# AMPEX

SERVICE BULLETIN

DATE: 20 March 1953  
MODEL: 300  
BULLETIN NO: 2  
PAGE NO: 1

## CORPORATION

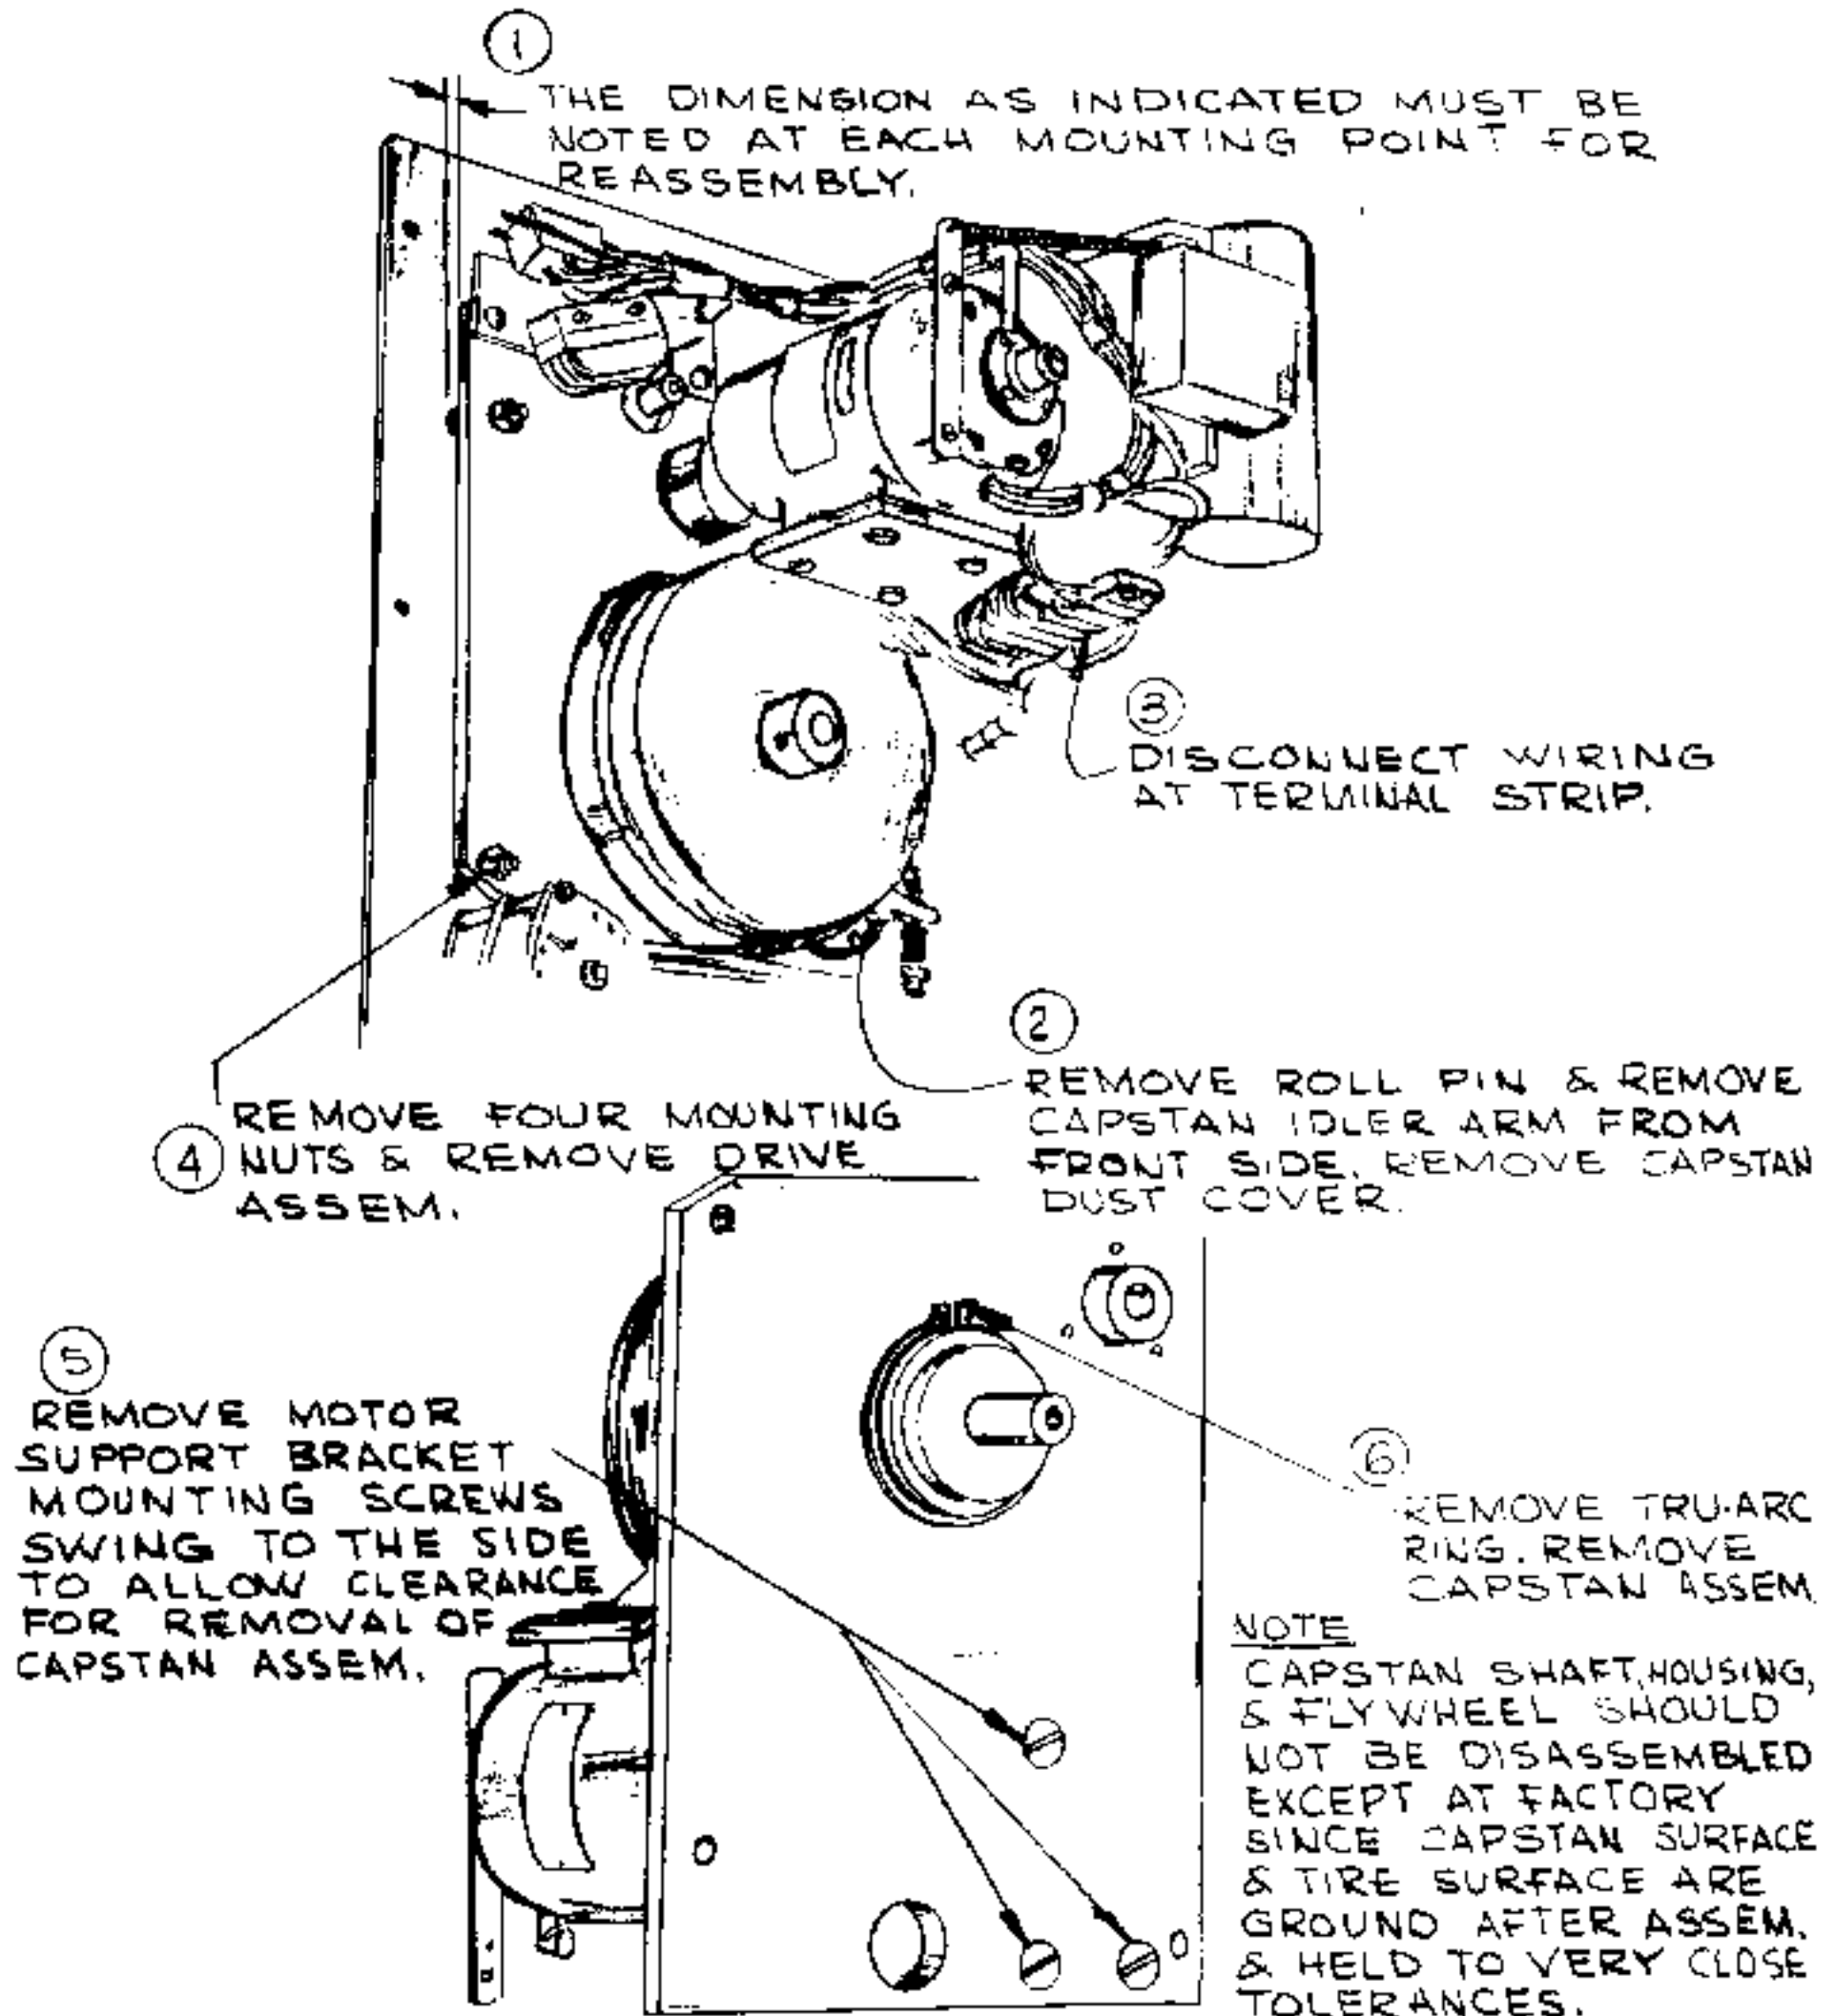
The Bodine Drive Motor which has been developed for the Model 300 runs at double the speed of the Cyclohm or Electric Indicator Drive Motor used on machines of Serial #113 to 699 and consequently uses a different size pulley. To install the Bodine Drive Motor therefore requires that a new hinge bracket be installed which will support the new motor in the proper position to engage the capstan flywheel. Also, since the windings on the Bodine Motor are different than on either the Cyclohm or Electric Indicator Motors, it must be connected in a different manner.

1. Remove retaining rings "A" on Capstan Idler link "B".
2. Remove Capstan Idler link "B".
3. Remove Capstan Idler arm from Top Plate.
4. Remove Capstan cap by loosening set screw "C".

5. Disconnect wiring harness from Drive Assembly terminal strip "D".
6. Remove Drive Assembly from machine by removing 4 elastic stop nuts "E" (only one shown).

7. Remove 4 screws "F" and drop solenoid mounting plate. Note that two screws are on the solenoid side and remainder on the opposite side of the plate.

8. Carefully remove drive lok pins "G". Be careful not to damage ears of casting.
9. Remove two bracket hinge pins "H".
10. Remove bearings from old brackets and install in new bracket.

14. The bumper should not determine the rest position of the motor. The bumper merely serves as an override bumper to damp out any motor oscillation that would cause it to bounce against tire after solenoid is de-energized. The rest position is determined by the motor spring versus the pressure of the drive solenoid spring adjustment. When properly adjusted the bumper should not quite touch motor while at rest except during shipment.
15. For modified wiring for Bodine Motor see attached wiring Diagram EA-1752.

ALLOW 8" LEAD LENGTH  
FROM MOTOR TO DIS-  
CONNECT SPLICES
